Belvac Production Machinery Technical Bulletin

ISSUE 2, VOLUME 24, AUGUST 2021

CC93 RBC CAM FOLLOWERS

Cam Followers prior to installation

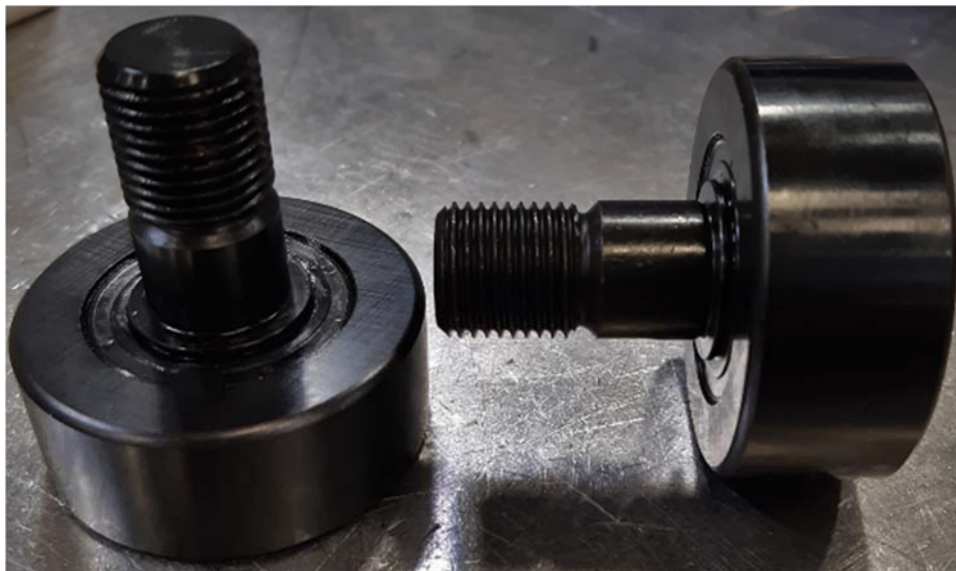
Belvac announces RBC cam followers have become standard on CC93 Trimmer machine platforms. These machine platforms have used only McGill cam followers for a number of years in both push and tooling rams. In response to customer inquiries, Belvac has evaluated RBC followers as an alternate for use on trimming equipment and determined that followers offered by RBC are successful in CC93 Trimmer cartridge assembly applications

- Belvac part number C101028 will be used for RBC cam followers and will make McGill cam followers (12159-CC93) obsolete.

Cam followers are physically marked with vendor name for clarity

All trimmers issued by Belvac Standard Product Engineering after July 15th, 2021 will utilize RBC cam followers. Some important details regarding the change:

Cam Followers installed on a CC93 Trimmer assembly

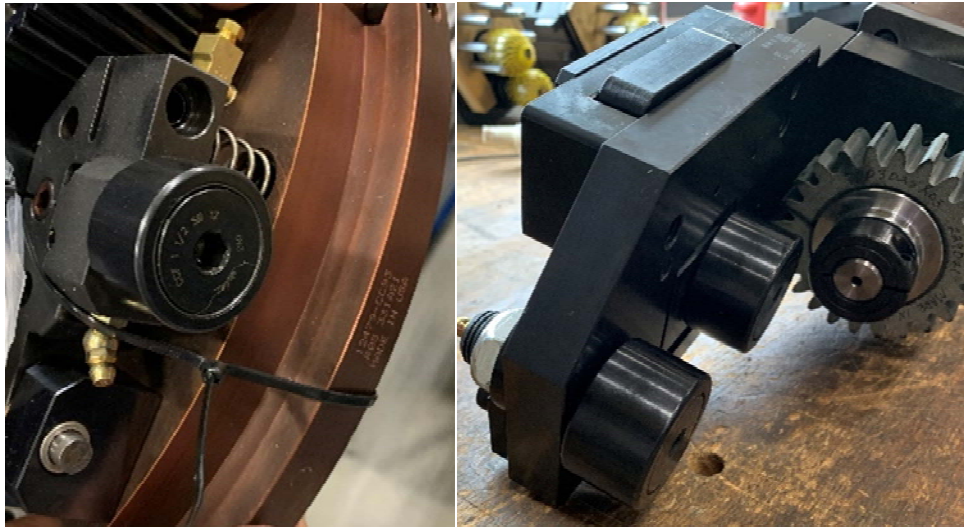
Contact Belvac Sales and Service to create a transition plan to RBC followers for existing equipment.
